**MUJARRAH CANAL BRIDGE
RAMADI, IRAQ**

**SIGIR PA-09-170
JULY 14, 2009**

SUBJECT: Report on the Mugarrah Canal Bridge, Ramadi, Iraq
(Project Number SIGIR PA-09-170)

Site Photo 7. Concrete deck reinforcing (prior to placing top mat, foreground)

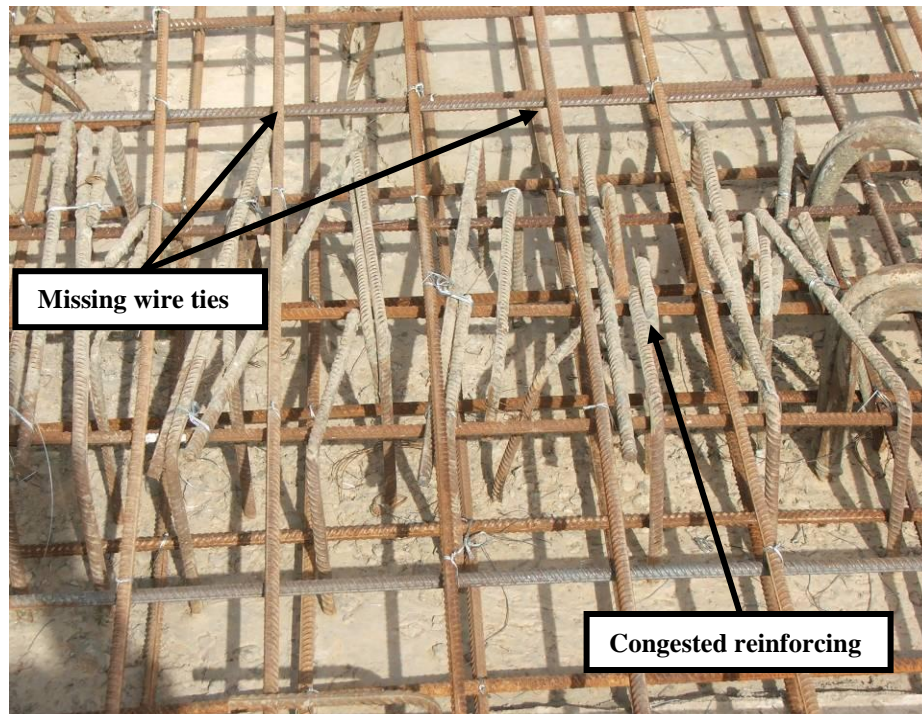
SIGIR noted several issues with the placement of the reinforcing for the concrete deck. For example, near the ends of the girders, SIGIR found areas of severe reinforcing steel congestion (Site Photo 9.) SIGIR is concerned that this configuration of reinforcing steel may prevent homogeneous concrete placement, which would result in voids in the deck. Since the purpose of the reinforcing steel in this area is to create composite action

SIGIR also noted that the bottom mat of reinforcing steel was placed directly on the precast-concrete deck pans. To provide composite action between the reinforcing and the concrete deck, adequate cover needs to be obtained around the reinforcing to permit stress transfer. Inadequate cover may result in the reduced capacity of the deck. SIGIR understands that it is a common practice for contractors to place chairs under reinforcing steel immediately before concrete placement. This helps avoid bending the chairs or rebar when walking on the matting as shown in Site Photo 7. If the contractor placed adequate chairs under the reinforcing steel prior to concrete placement, this is not an issue.

Command Comment. SIGIR's concern with the reinforcing steel matting placed directly on the deck pan is valid. However, it is common practice for contractors to place chairs under reinforcing steel immediately before concrete placement. This helps avoid bending the chairs or rebar when walking on the matting as shown in photograph 7. If the contractor placed adequate chairs under the reinforcing steel prior to concrete placement, this is not an issue.
